IN THE MATTER OF An application RM23.185 by Dunedin City Council for the continued operation and closure of the Green Island Landfill, Dunedin

**STATEMENT OF EVIDENCE OF TIMOTHY MICHAEL BAKER ON BEHALF OF
OTAGO REGIONAL COUNCIL**

21 February 2025

Figure 1: Monitoring Well Location including proposed new multi-depth well location.

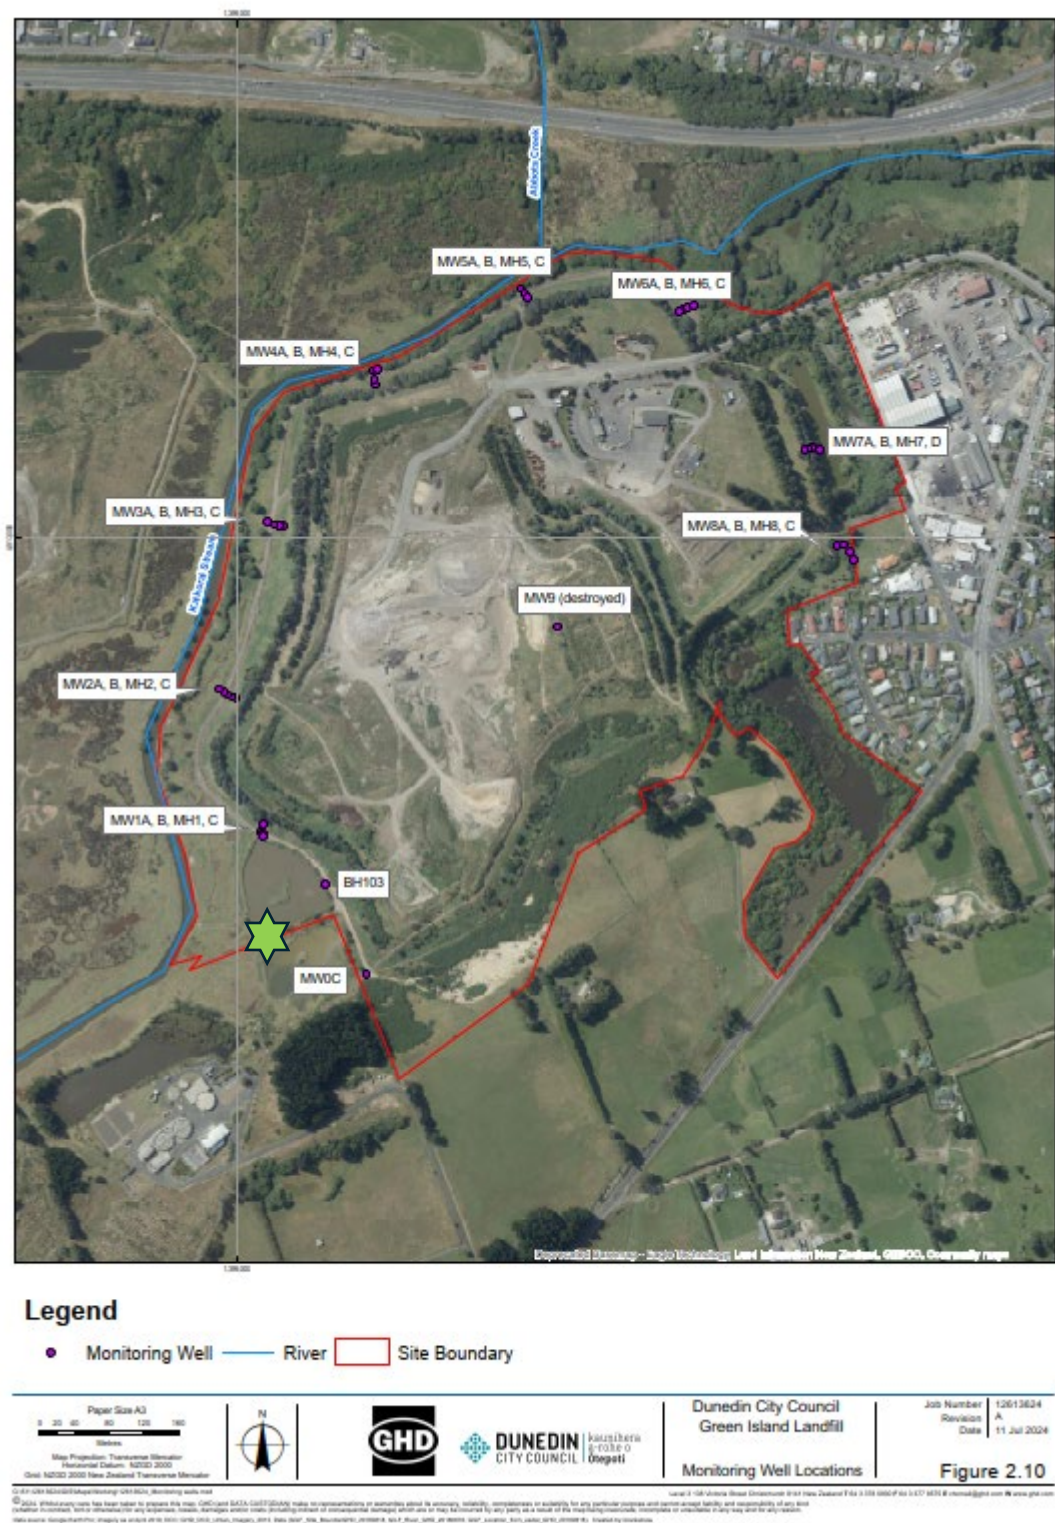
- 7.6 Furthermore, the absence of deep wells along key downgradient transects (there are only Deep wells on lines 2, 4 and 7) means there are large gaps in the spatial coverage of deep groundwater monitoring.

- 7.8 In my 2024 technical memorandum, I recommended further deep wells added, at a minimum, to monitoring lines 1 and 3, and a new clustered well closer to the

estuary. This would provide a continuous network of deeper wells around the 'down-gradient' side of the landfill.

- 7.9 Following discussion onsite with Stephen Douglass of GHD (acting for the Applicant) we agreed that a good location for the new clustered bore would be at the end of the causeway between the two southern stormwater ponds. I have marked this location with a star on the Figure 1 (**Attachment A**). This site would ideally include wells screened in the UKEM, LKEM and the Abbotsford mudstone.

10.3 Condition 38 refers to the monitoring well location map. I would like the new wells discussed in my paragraphs 7.6-7.8 added to the map (that is the new clustered well, 1D and 3D). These wells should be installed as soon as practicable following granting of consent and be incorporated into the monitoring programme immediately upon completion of installation.

Figure 2: Typical Leachate Trench Cross Section

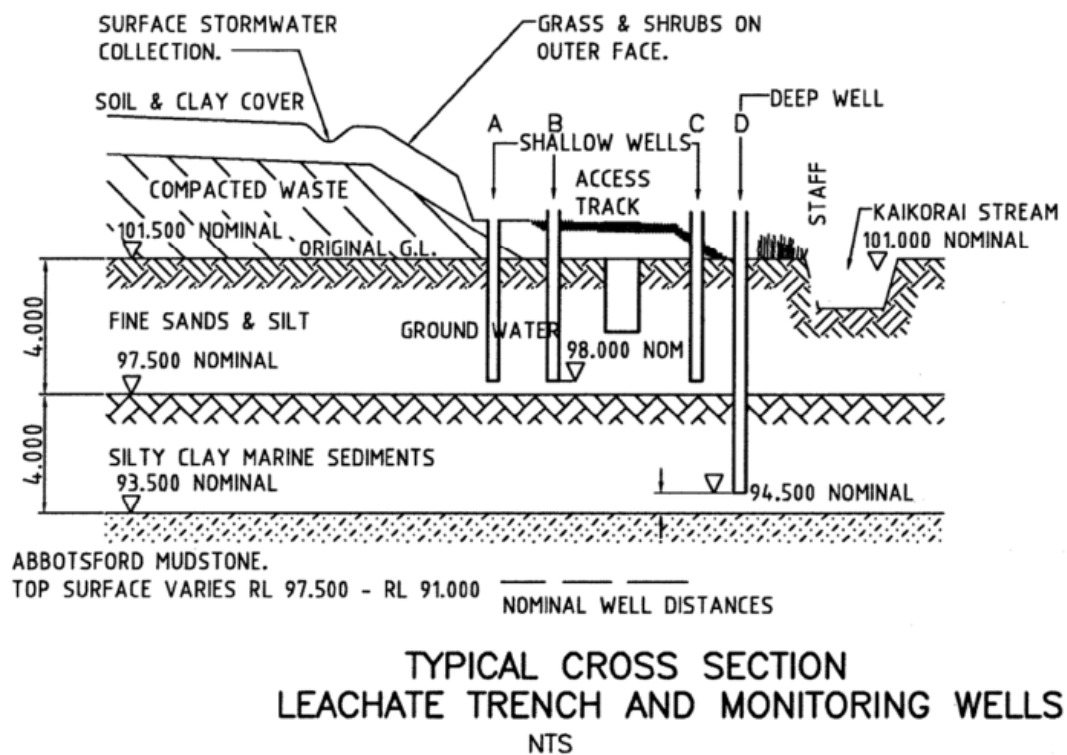
- 6.3 Figure 2 (**Attachment A**) is from the 2024 GW Report and shows the typical cross section and is replicated below. Noting the 'D' wells, which are the deep wells, are only present on lines 2, 4 and 7.

- 6.4 The intent of the C and D wells is to monitor groundwater moving beyond the landfill boundary and toward Kaikorai Stream/Estuary. However, as discussed in the next section, I have some concerns over the spatial coverage of these wells, and the fact that the deeper D wells are only present at some locations.
